**Technical Audit Report of Electric Loco Shed,
Lallaguda, for maintenance of bearings of three phase
locomotive Traction Motors (TM) and Motor
Suspension Units (MSU)**

Report No.: RDSO/2016/EL/TAR/0003 Rev '0'

Issue Date: 29.03.2016

Photo 2: Drop Test Probes

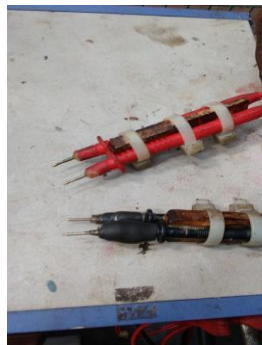
- (i) Commutator profiler is lying defective.
- (ii) Drop test procedure was seen and the staff and supervisor were counselled for following the proper procedure as given in SMI-51. The staff was not aware about significance of placement of current and potential probes. It was also advised to use a proper probe having current and potential leads spaced apart 20mm.
